DESIGN ADVISORY BOARD

DESIGN ADVISORY BOARD Tuesday November 9, 2021 3:00 PM

To: The Design Advisory Board
From: Mary O'Neil, AICP, Principal Planner
RE: ZP21-509 72-76 Elmwood Avenue
Date: September 28, 2021

To: The Design Advisory Board
From: Ryan Morrison, Associate Planner
RE: ZP-21-732, 278 Main Street
Date: November 9, 2021

ELEVATIONS

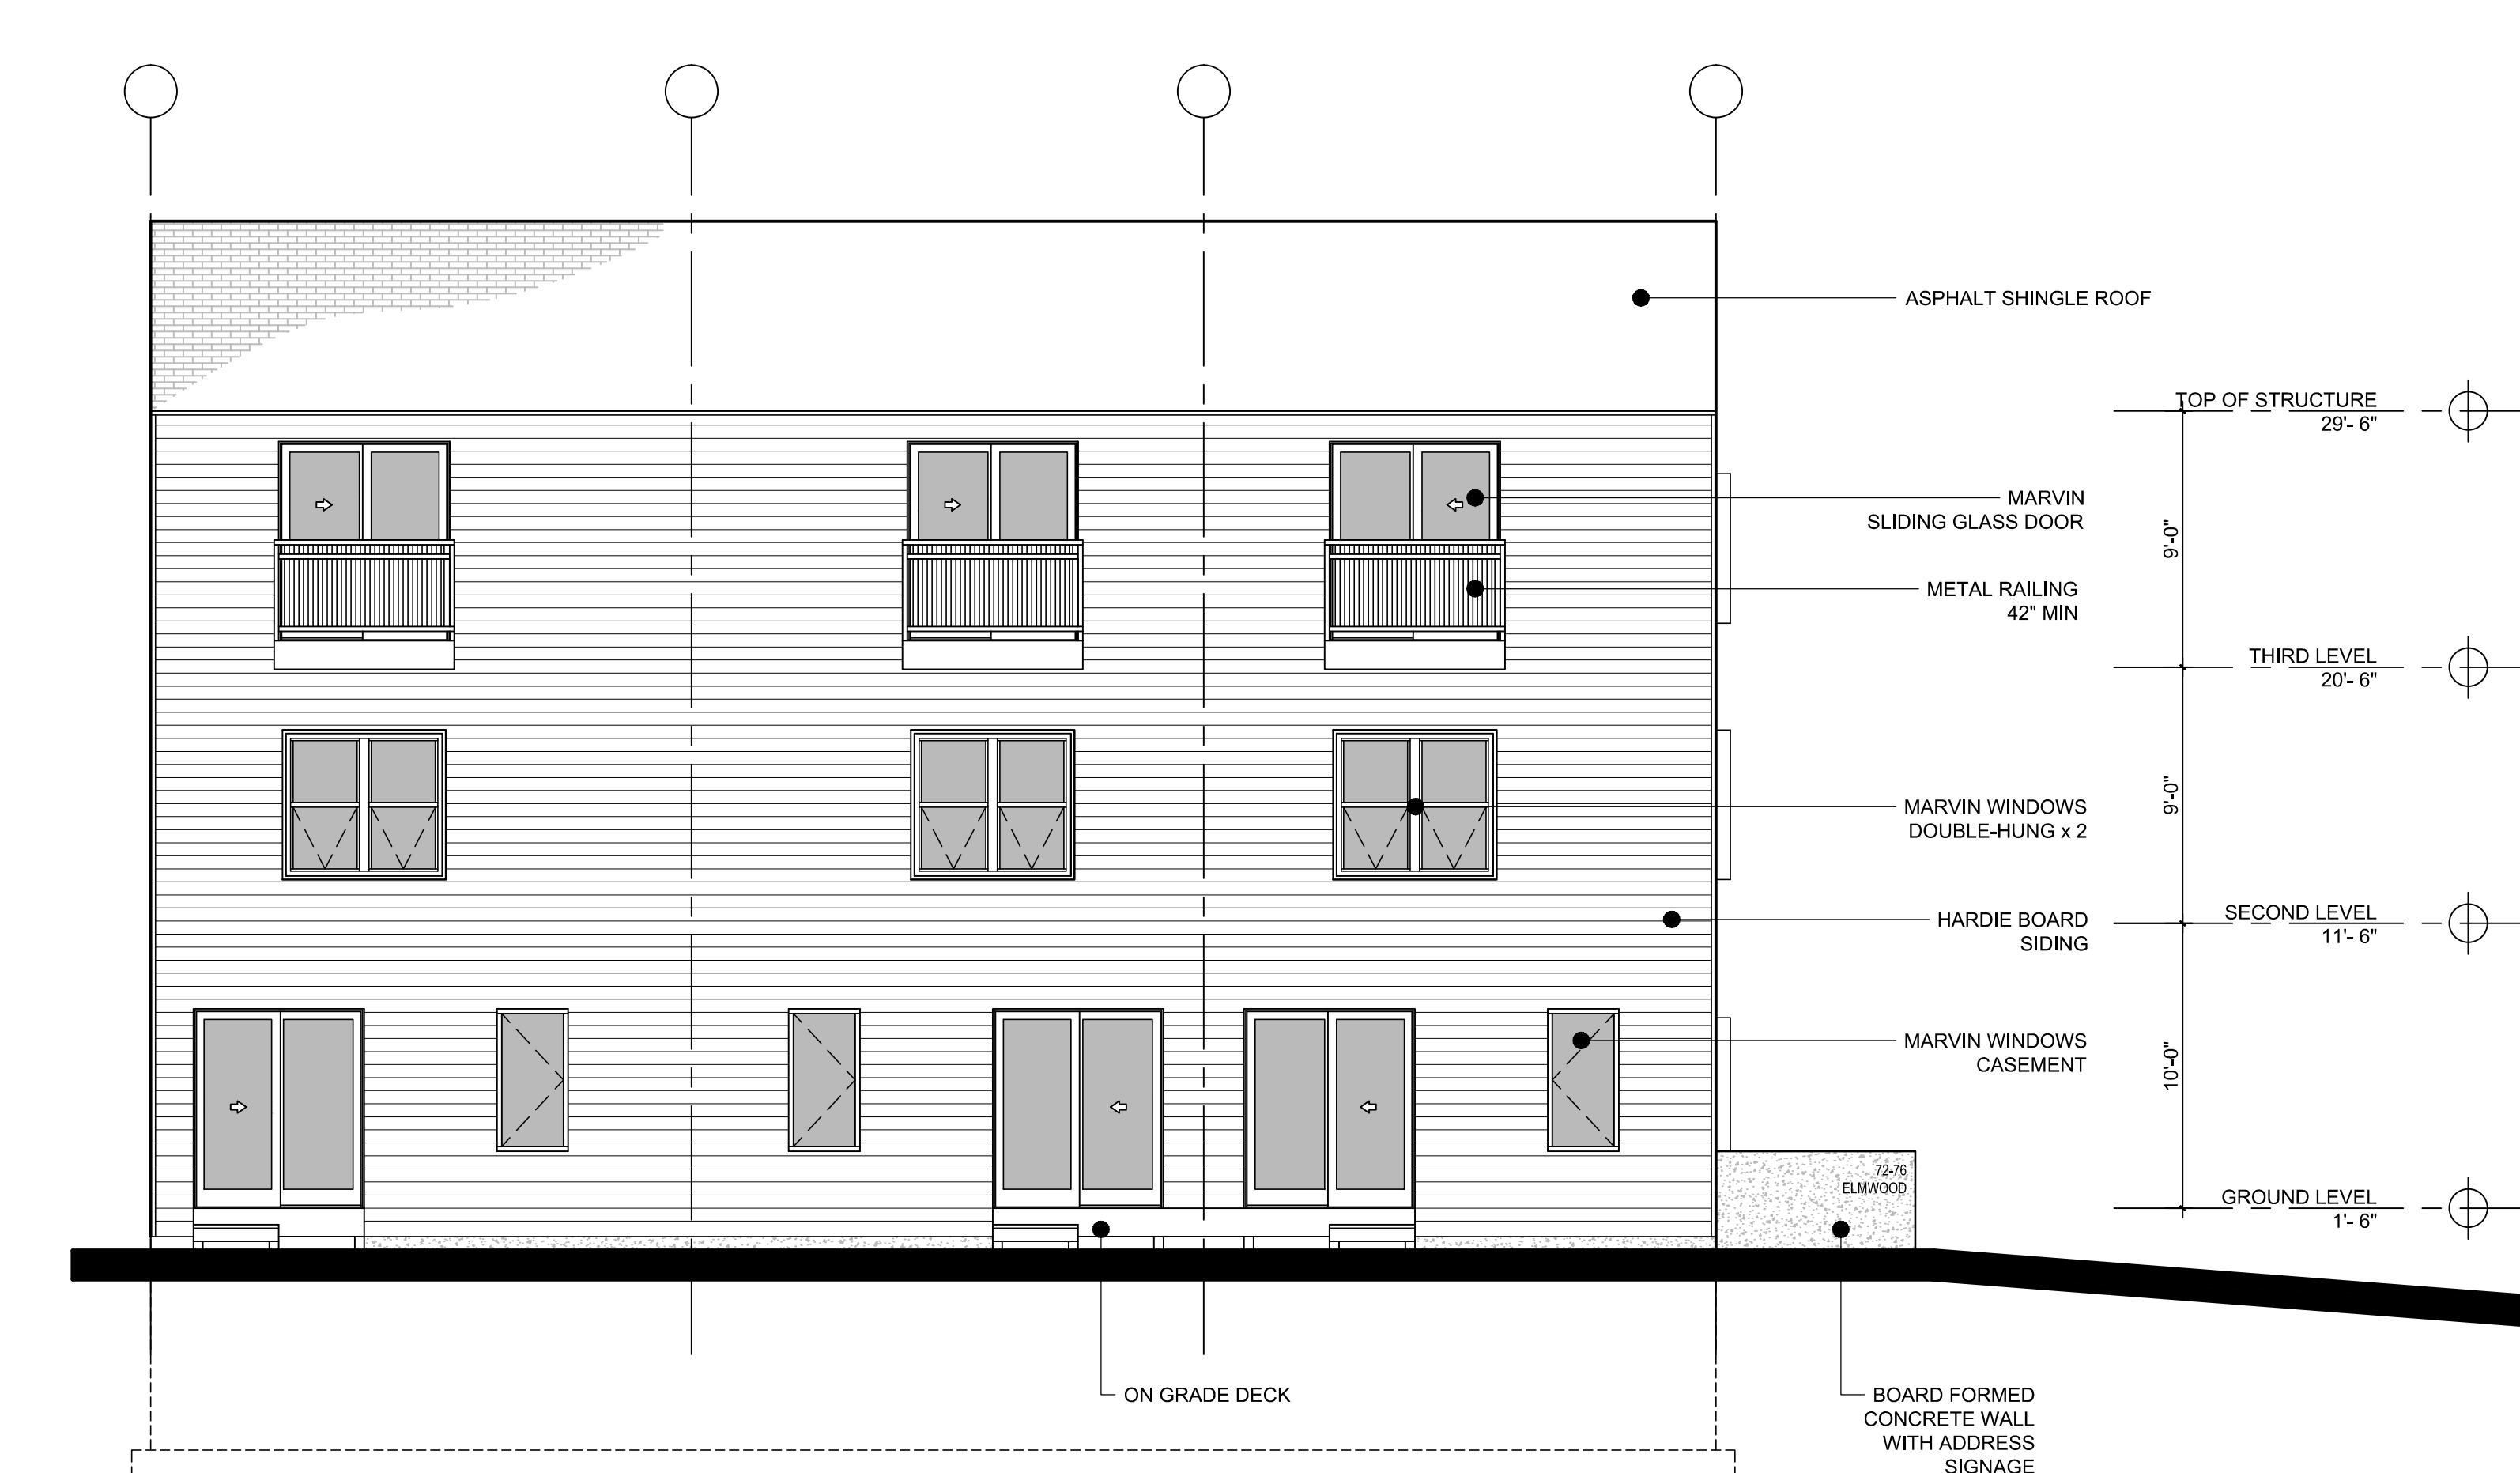
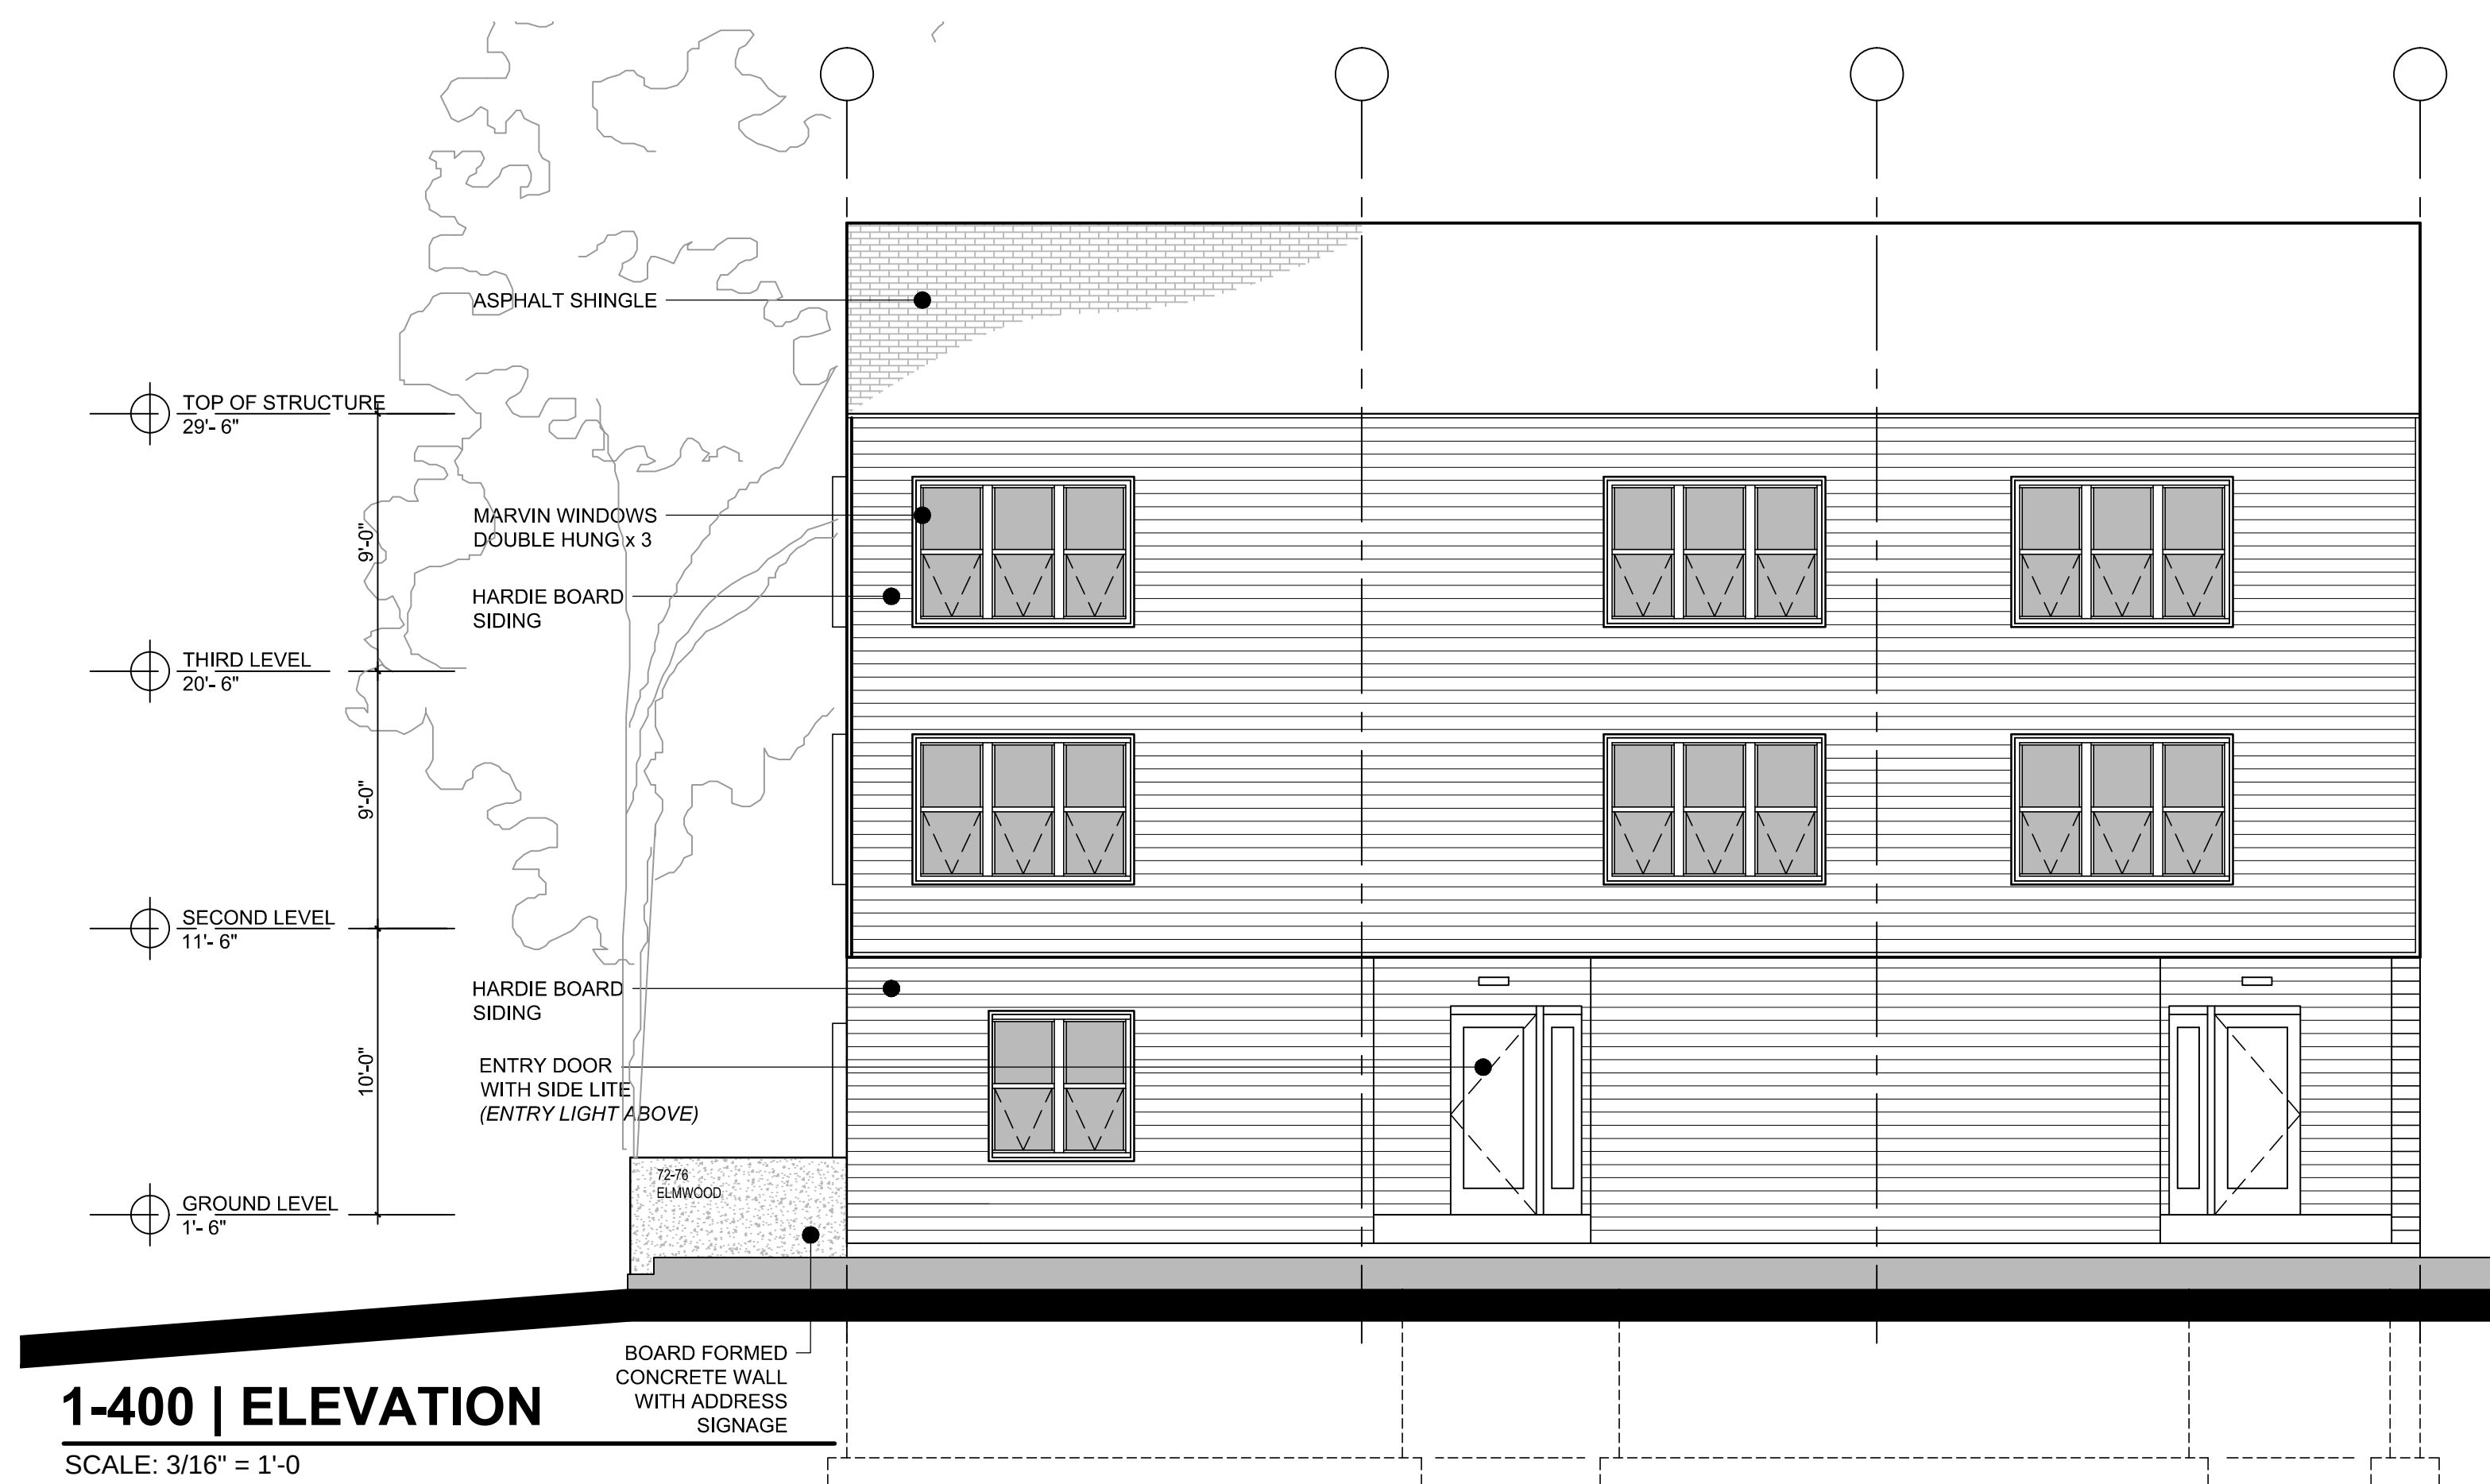
The proposed building has a modified cat-slide roof with dual pitch and zero eave extrusion. In style it reads as a modern infill.

As designed, the building lacks typical façade articulation such as bays, horizontal and vertical façade articulation, porches, patios, articulated bases, step-backs or other street level details. Windows are stacked, however, providing a measure of arrangement. The plan is modernistic with a simplified form and little detailing. The only interest provided is the angular and asymmetrical roof line.

Plans include fiber cement siding, with metal frame surrounds on windows and an asphalt shingle roof. All are considered acceptable for new construction.

- Any intended mechanical equipment (HVAC, Condensing Units, mini-splits, etc) shall be illustrated on the site plan/building elevations as appropriate. No mechanical equipment shall be allowed on the primary (westerly) elevation. Screening may be required elsewhere.
